**VILLAGE OF WINDSOR
VILLAGE BOARD RESOLUTION 2023-11**

**APPROVAL OF THE PHASE 7 AMENDMENT TO THE DEVELOPMENT AGREEMENT FOR BEAR
TREE FARMS**

WHEREAS, the Village Staff and Consultants have reviewed the Petitioner’s request and prepared a Staff Report dated February 09, 2023 (the “Staff Report”) recommending approval, subject to certain conditions specified in the Staff Report; and

Project No.: 122.1386.30
Sheet C 505

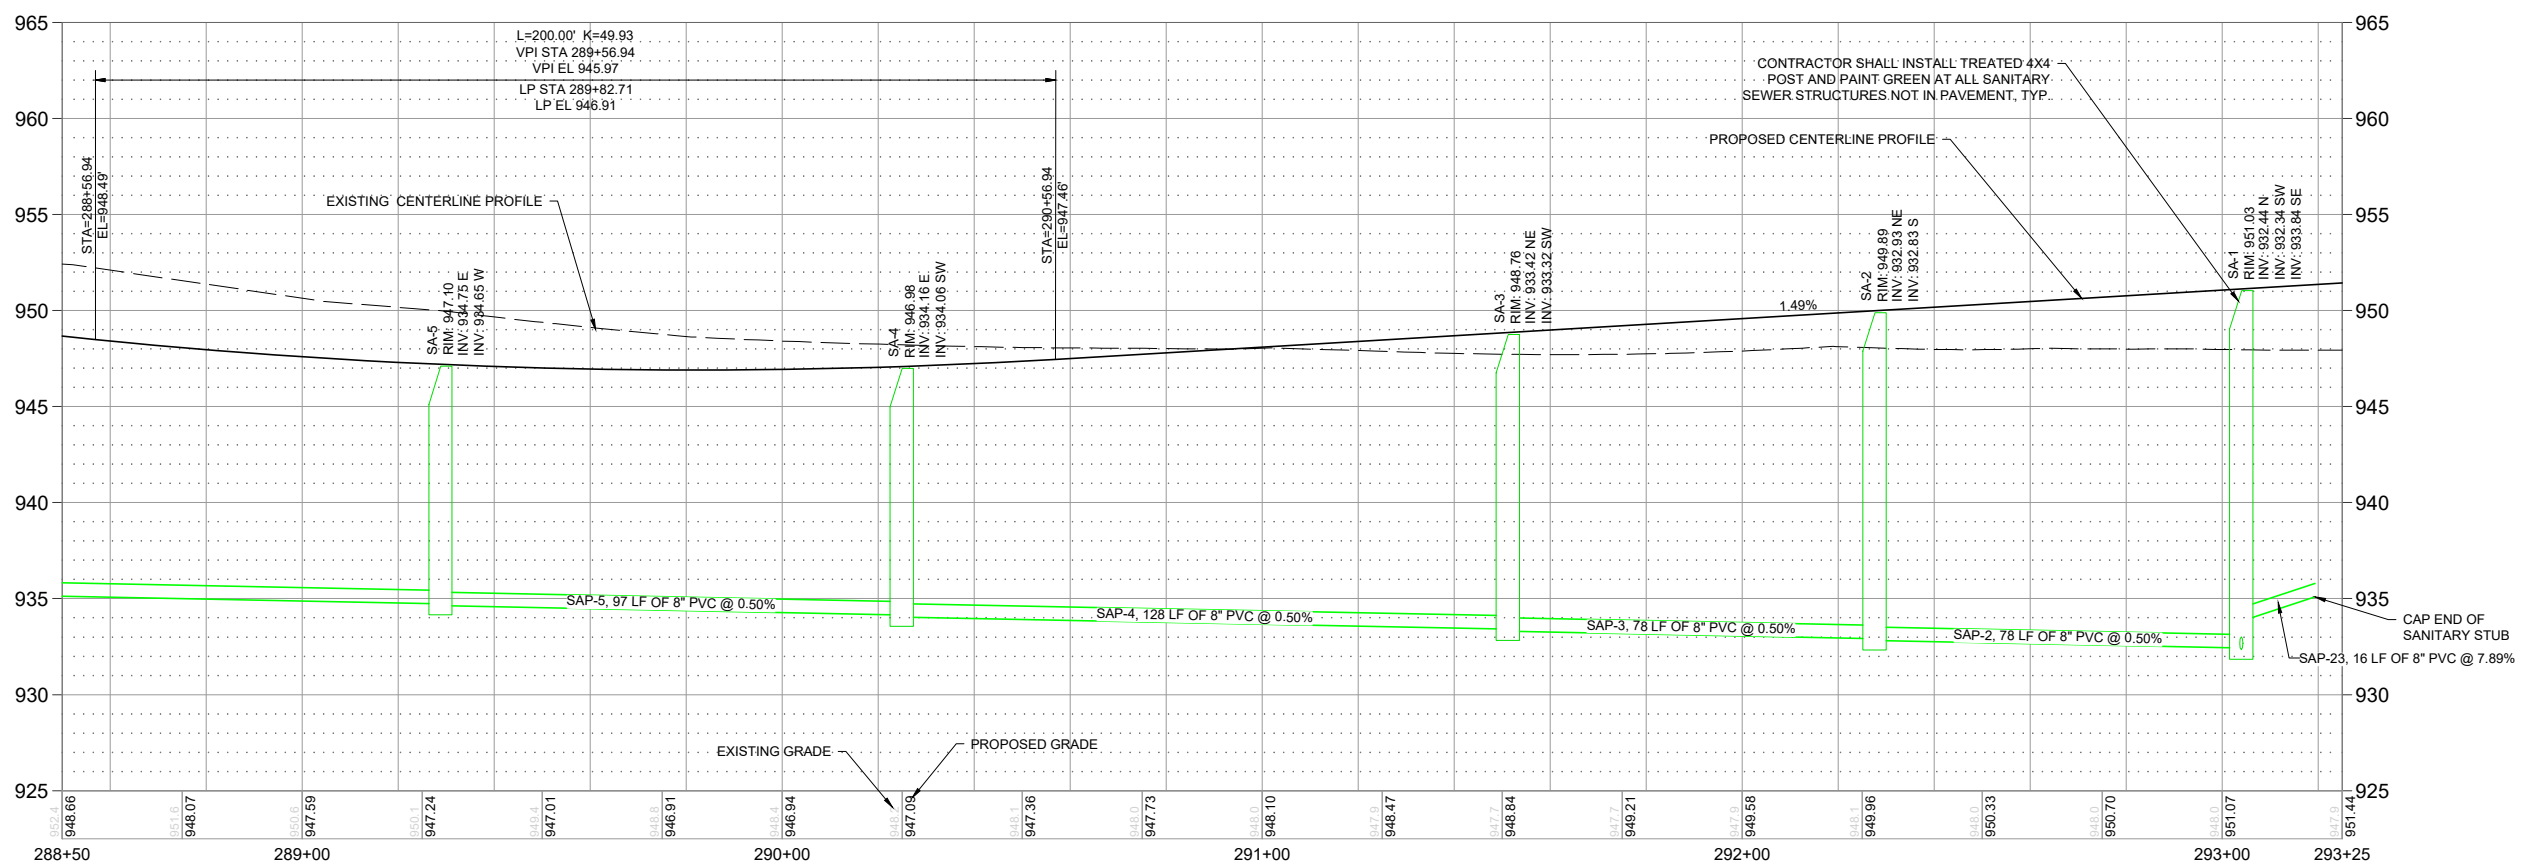
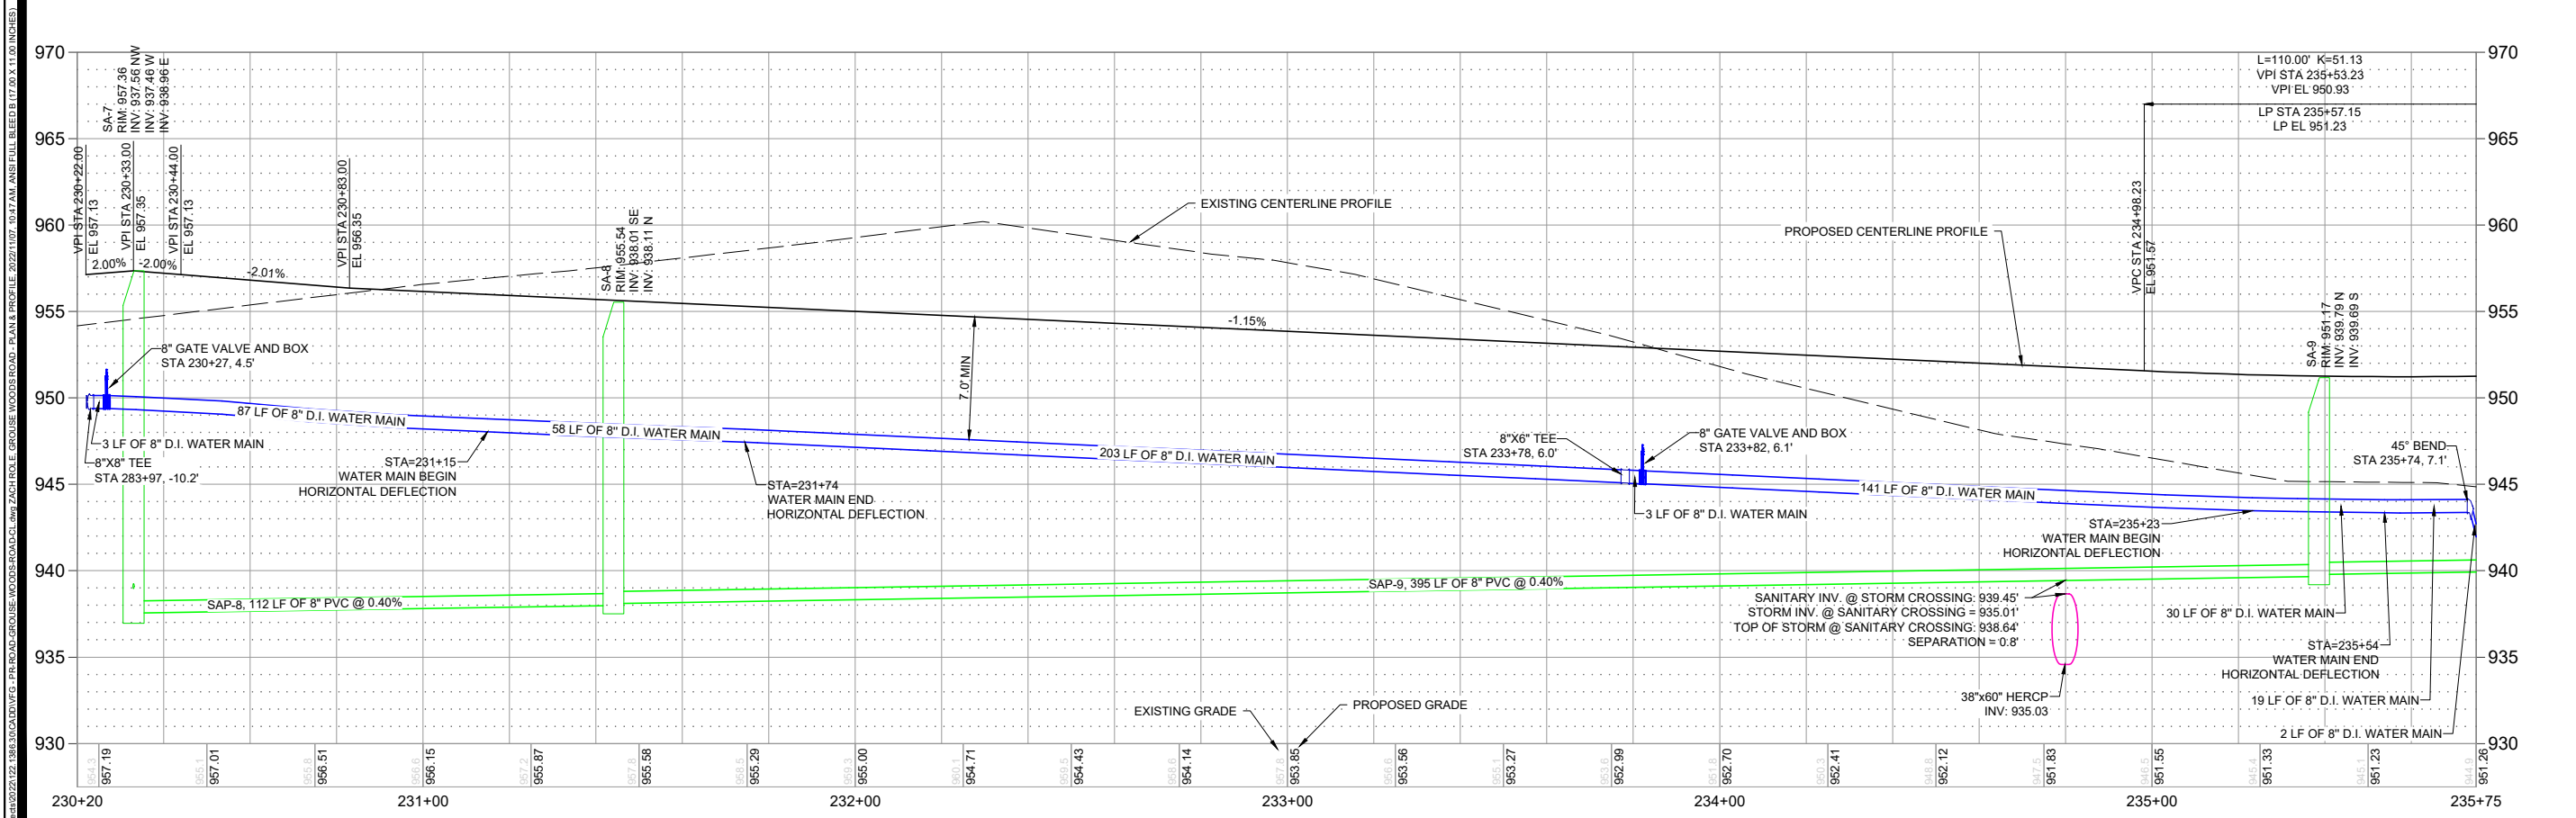
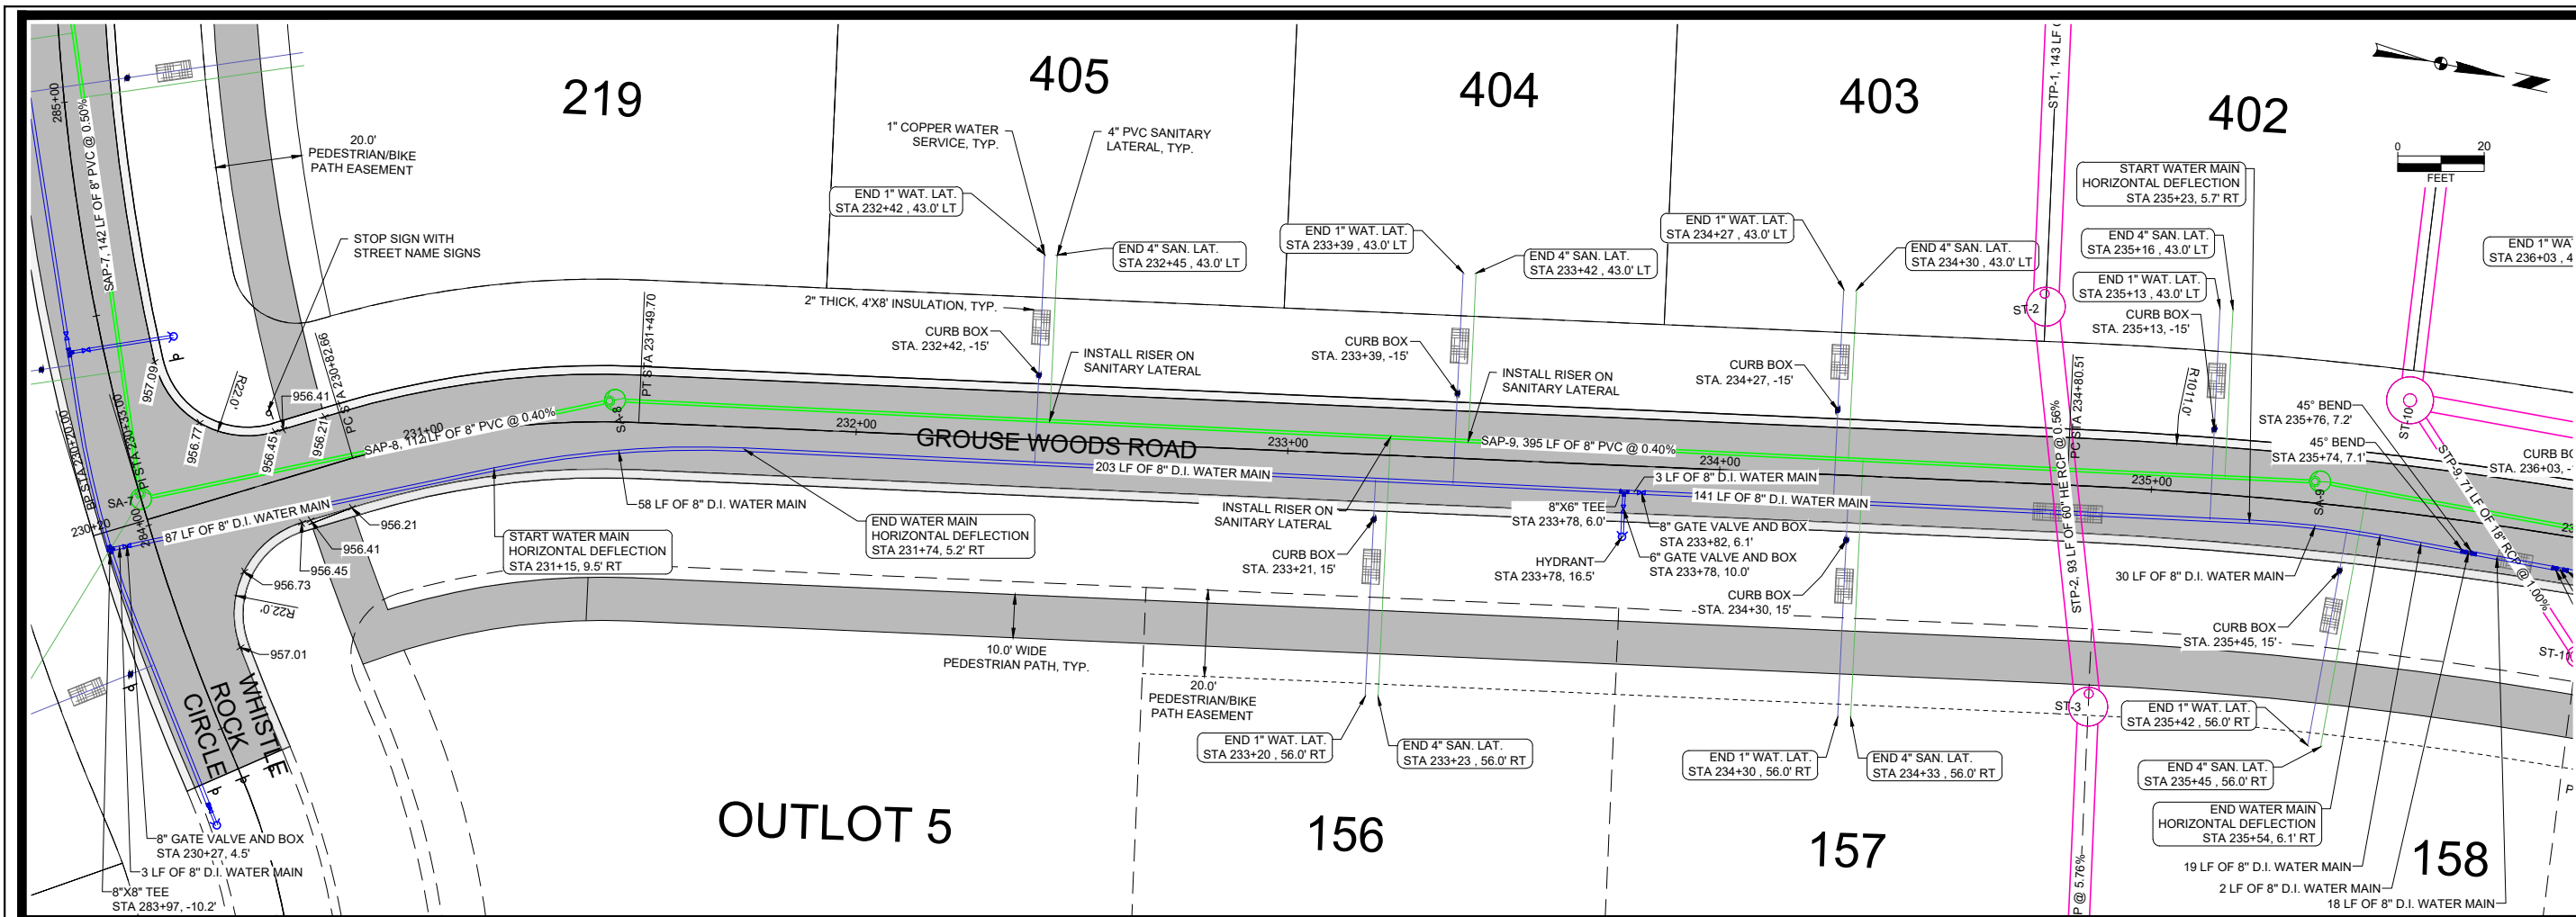
8. Sheet C 505: Sanitary sewer exceeding 15' of cover shall be constructed with SDR 26 pipe and shall be noted on the plans.
9. Sheet C 507: We recommend that the water main offset shown near STA 236+00 be eliminated in favor of a gradual lowering of the water main. The offset near STA 238+00 appears to be unavoidable. An 8" gate valve should be constructed east of the watermain cross to properly isolate water main.

Project No.: 122.1386.30
Sheet C 508

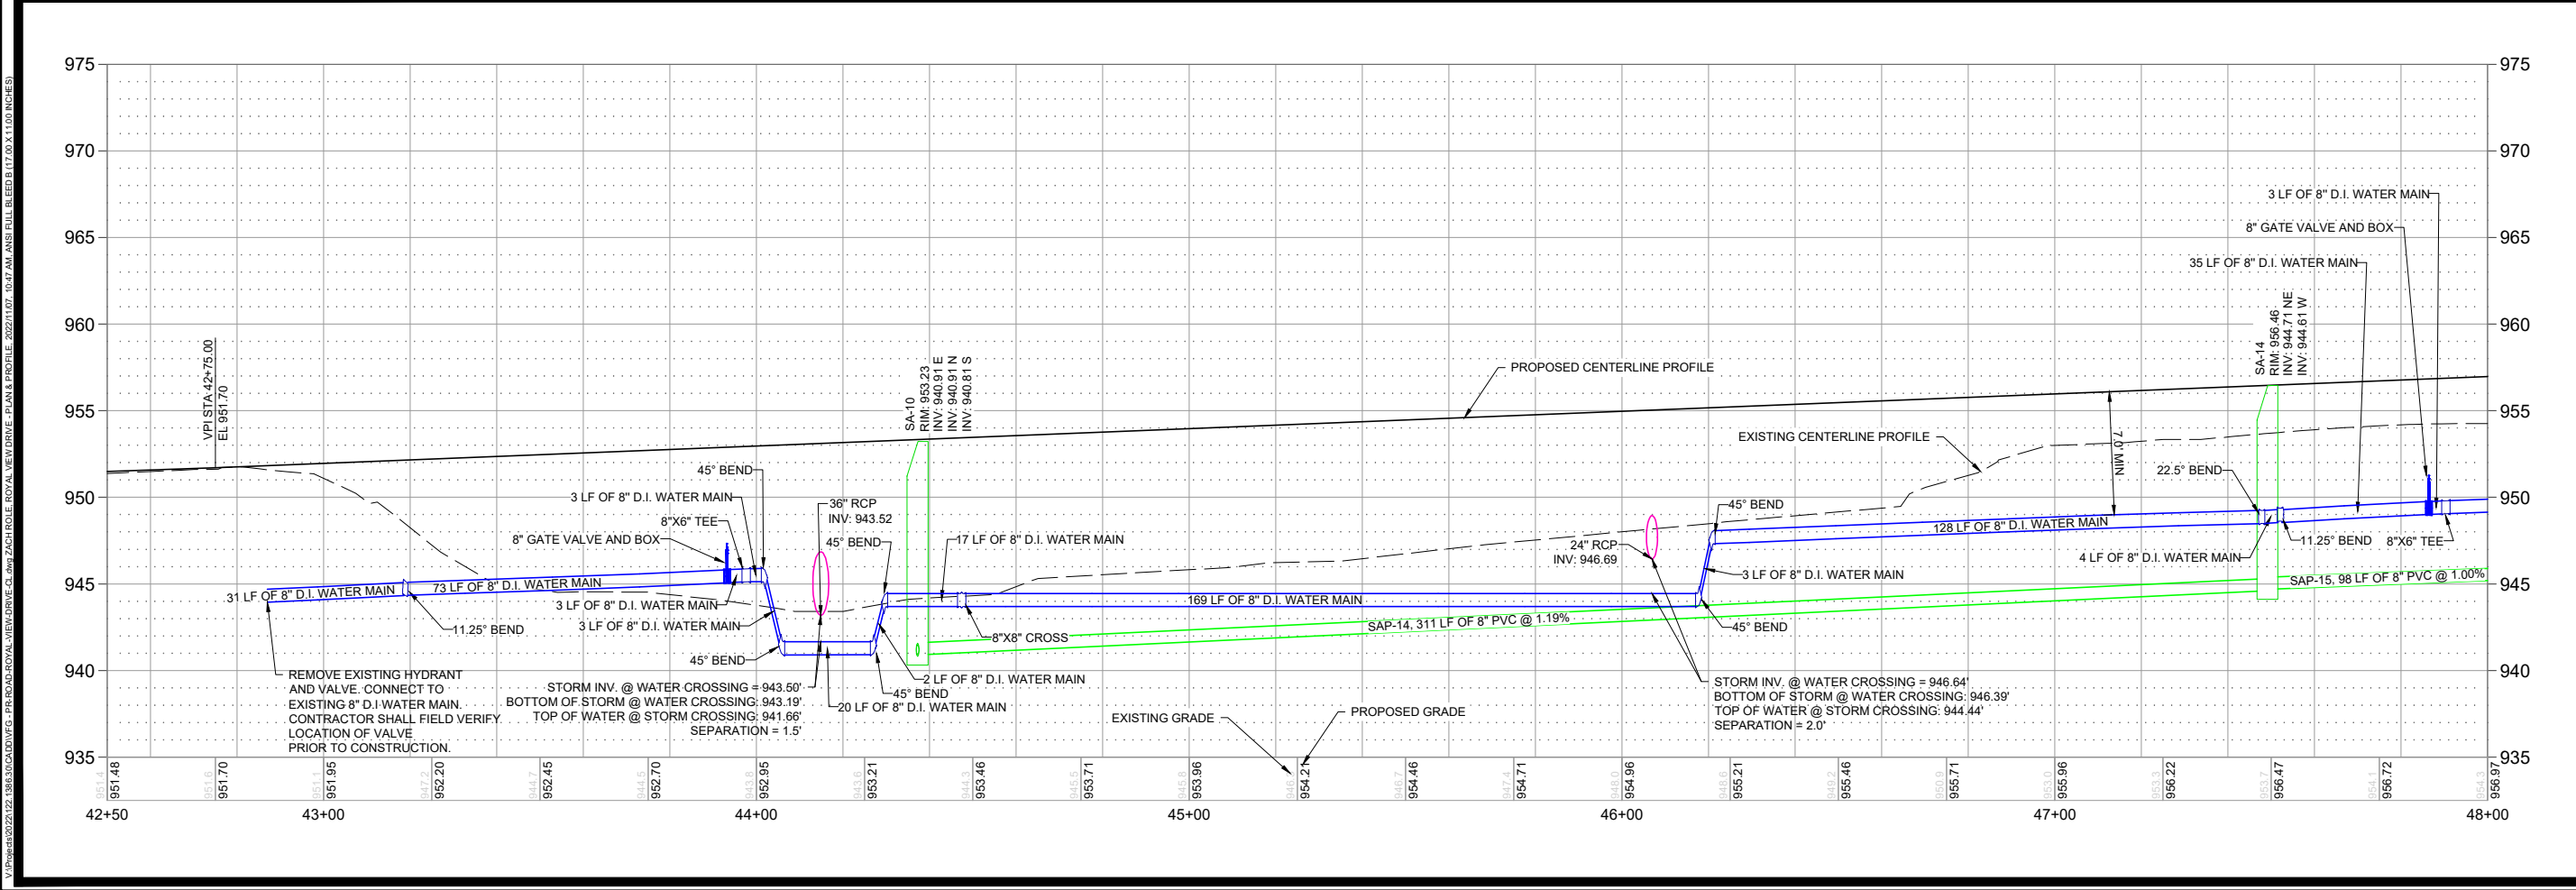
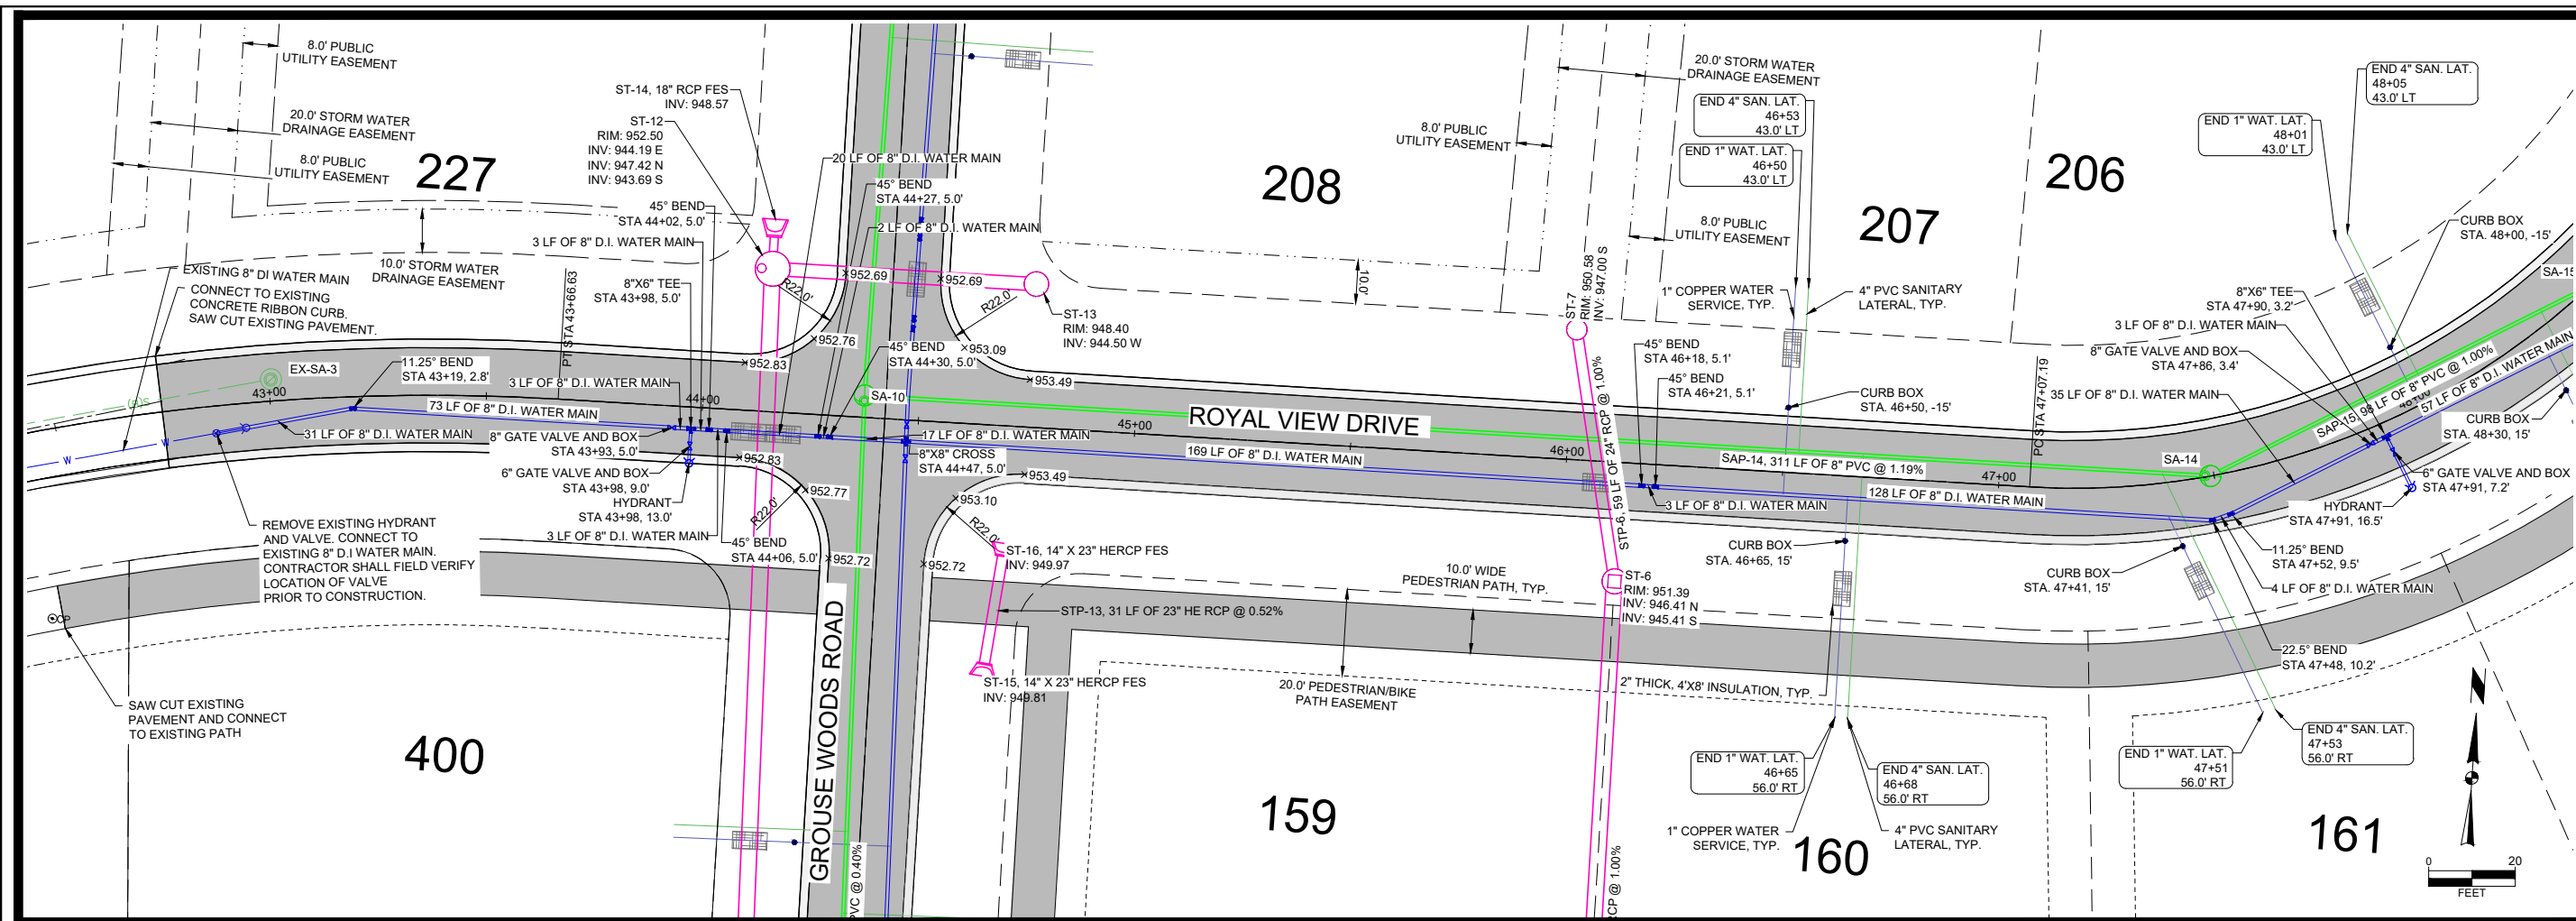
10. Sheet C 508: Main line valves are shown near hydrant tees, which is a good idea. We recommend these be put on the uphill side of each hydrant to allow for better elimination of future air collecting. This note applies to all hydrants on the plan set.
